Doc Description: Addendum 2 - Construction of Boat access on Lower Elk River

**Request for Quotation
(Construction Services - Kanawha County, Lower Elk River (5) Boating Access Site Project)**

**WV DNR
KANAWHA COUNTY, WEST VIRGINIA
PROPOSED
ELK RIVER BOATING ACCESS SITES**

**ADDENDUM #2
February 14, 2020**

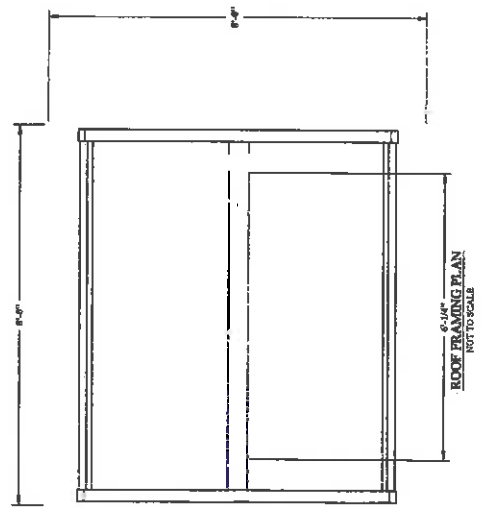
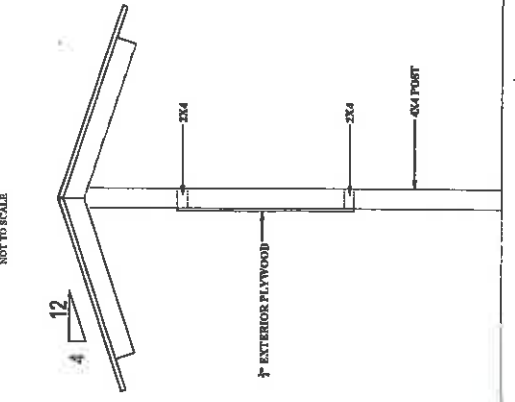
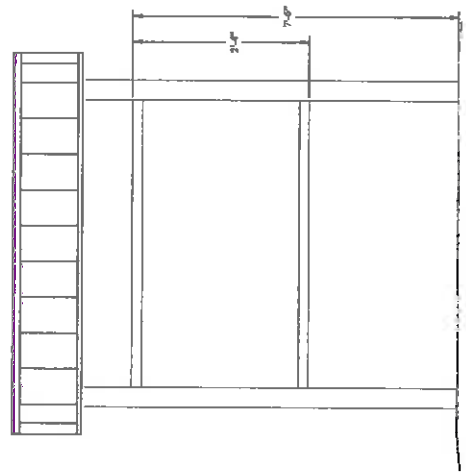
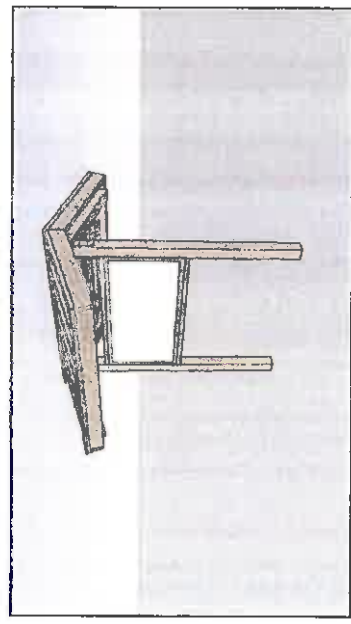
7Q.) Kiosk location and detail clarification.

Big Chimney – Sheet 15

7A.) See revised detail sheets:

SHEET NO. **16**

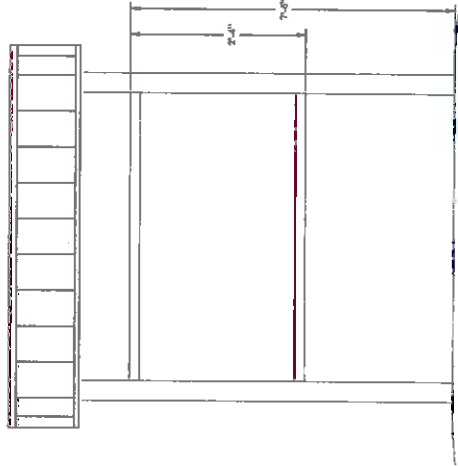
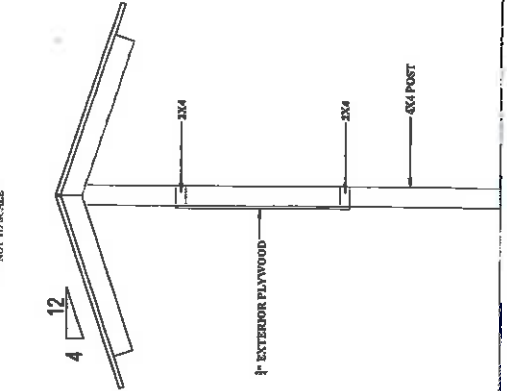
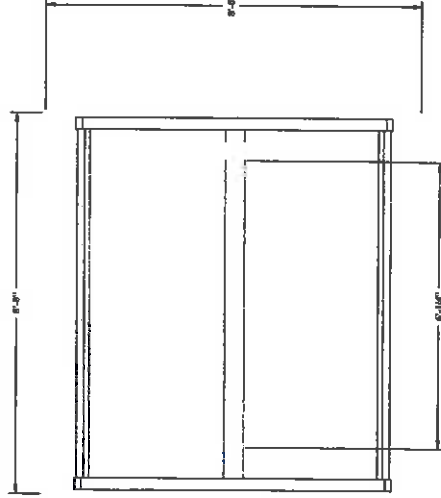
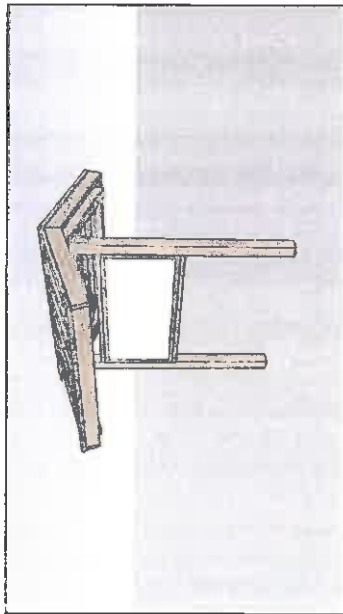
Blue Creek – Sheet 16

SHEET NO.
10

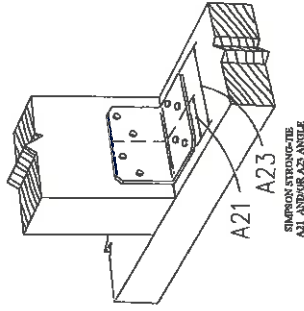
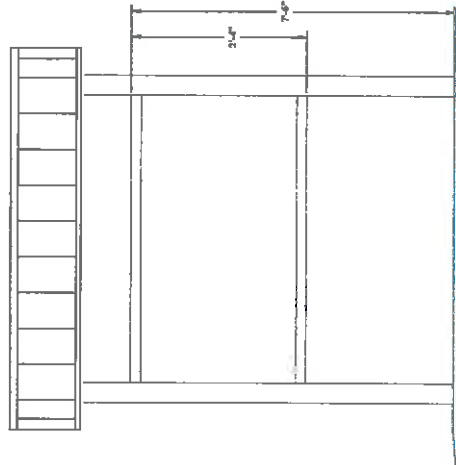
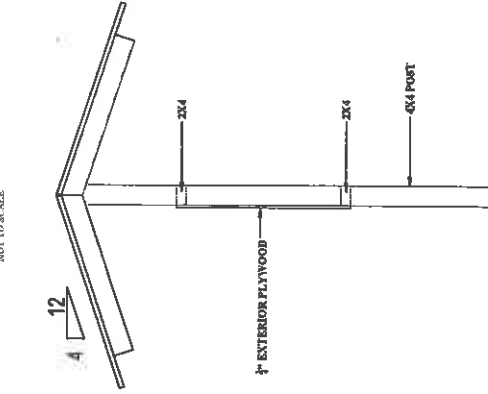
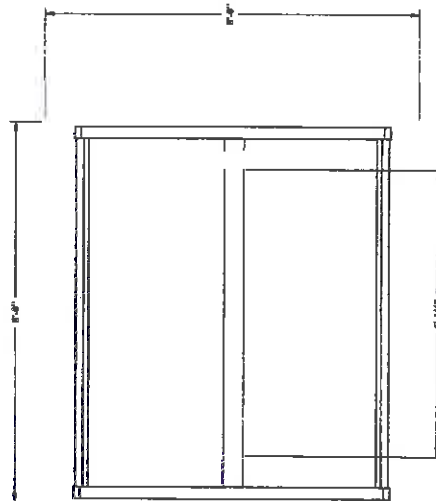
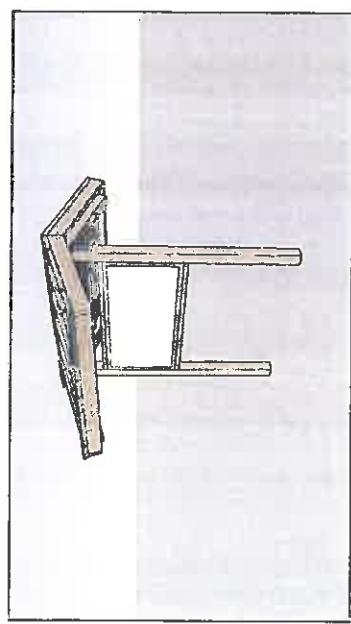
Clendenin North – Sheet 10

PROJECT NO.: 19-01-030-3321
SHEET NO.: 10

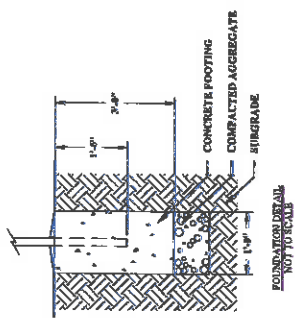
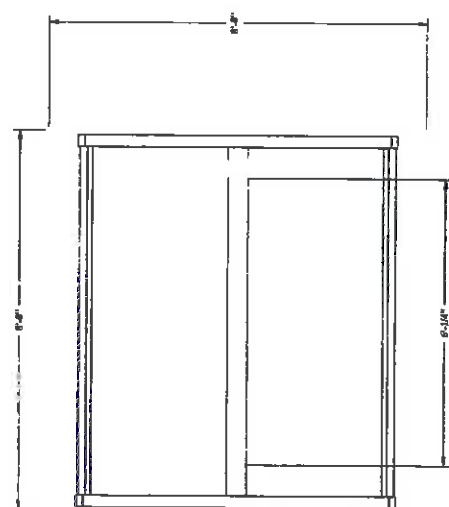
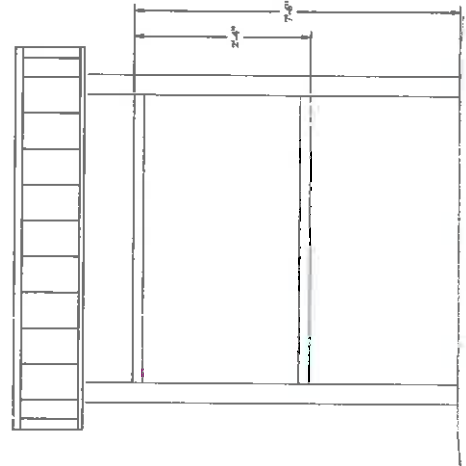
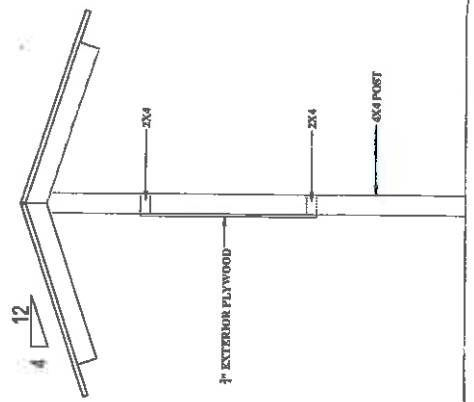
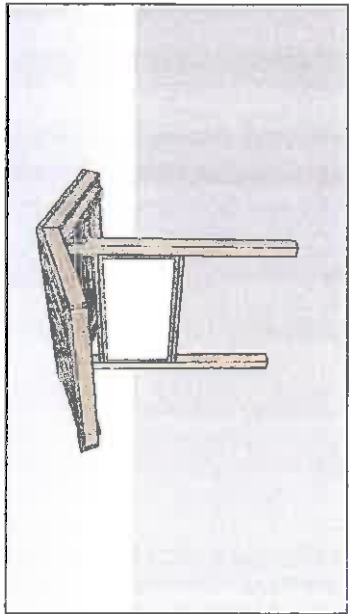
Coonskin – Sheet 10

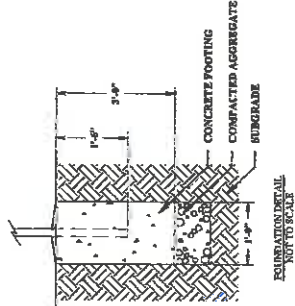
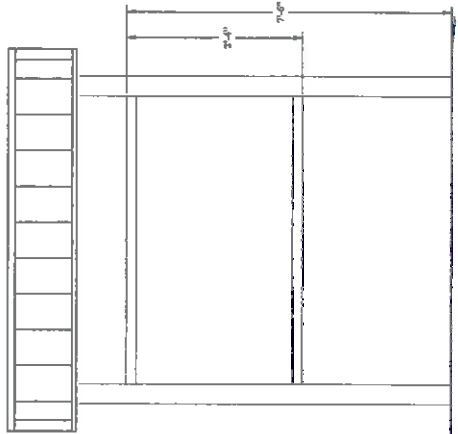
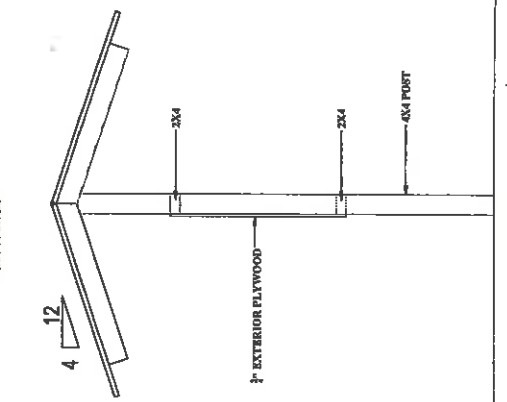
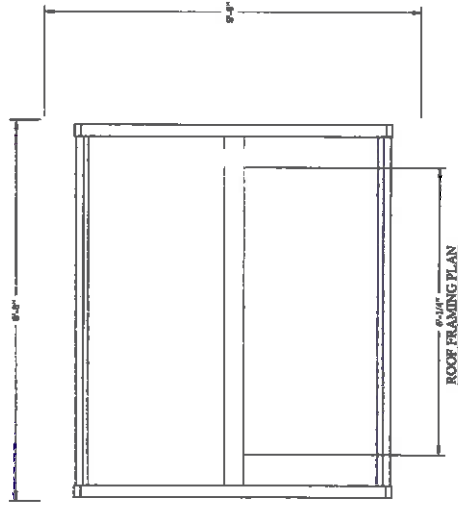
Clendenin South – Sheet 13
